1.0 GENERAL INFORMATION

1.1 FACILITY AND PROCESS OVERVIEW

This chapter of the revised draft Safety Evaluation Report (DSER) discusses general information contained in Chapter 1 of the revised Mixed Oxide Fuel Fabrication Facility (MFFF or the facility) Construction Authorization Request (CAR) (Reference 1.1.3.1). Chapter 1 of the MFFF revised CAR provides general information about the facility processes and the site. It consists of a general facility description, material flow, and process overview. The objective of this chapter is to familiarize the reader with the pertinent features of the proposed facility and the site.

Figure 1.1-1 MOX Fuel Fabrication Facility Controlled Area Boundary

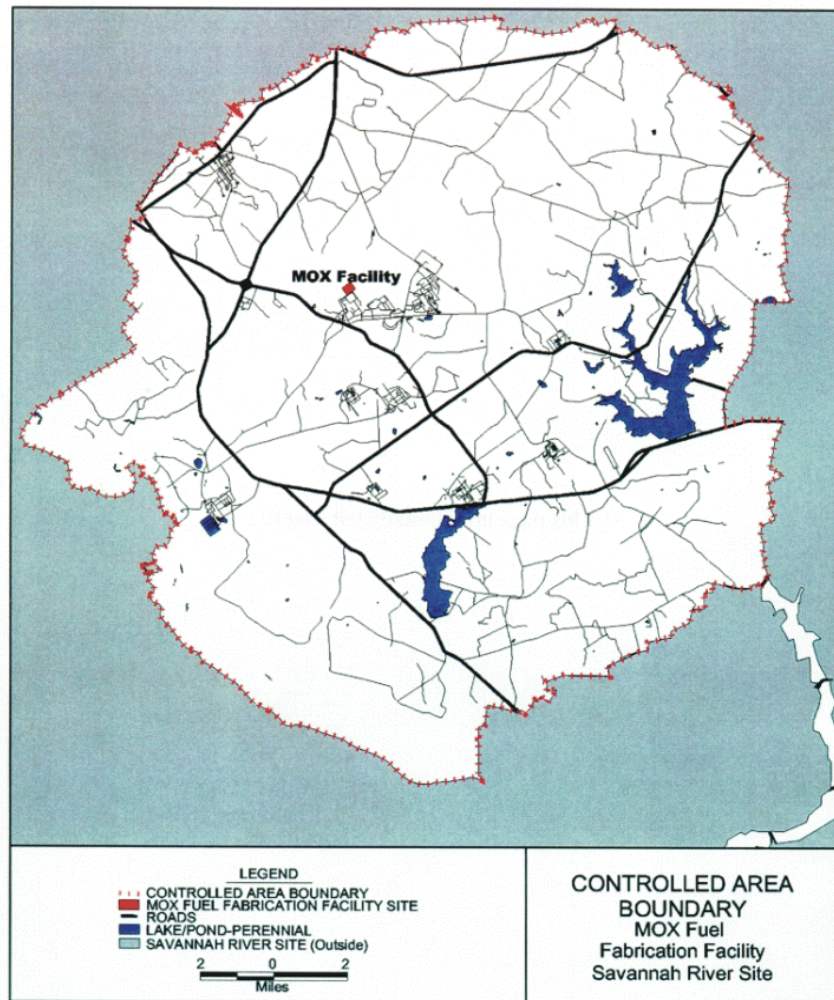
The applicant has chosen the controlled area boundary to be largely coincident with the boundary of DOE’s SRS. The SRS boundary is the boundary for which DOE currently controls access to SRS. The SRS boundary is shown in Figure 1.1-3 in the revised CAR, which has been reproduced as Figure 1.1-1 in this revised DSER. As shown, the controlled area

proposed by the applicant includes over 300 square miles (777 km²) of the SRS. DCS has committed to enter into an agreement with DOE (Reference 1.1.3.1) whereby DOE would continue to control access to the SRS site boundary using its existing methods -- a combination of physical barriers (such as wire fencing and gates at points of site access along state highways) and administrative controls (such as posting and border surveillance by DOE security force patrols). Since the DOE infrastructure, programs, and personnel regarding SRS site security are already in place, DCS proposes to control access to the MOX facility's controlled area using the established DOE security system.

The staff recognizes that roads used by members of the public traverse the proposed controlled area. This situation was considered during the 10 CFR Part 70 rulemaking. In Reference 1.1.3.2, the Commission stated that use of the integrated safety analysis to determine the risks to individuals who make infrequent visits to the controlled area would need to consider second-order effects such as the probability of the individual being present at the time that any hypothetical accidents occurred. The Commission concluded that this level of detail is

Accordingly, the staff finds that the applicant's proposed location of the controlled area boundary meets the requirements in 10 CFR 70.61(f) and 10 CFR Part 20. A DCS-DOE agreement to control access to the controlled area has not yet been reached, and will be submitted by DCS as part of its application for an SNM possession and use license.
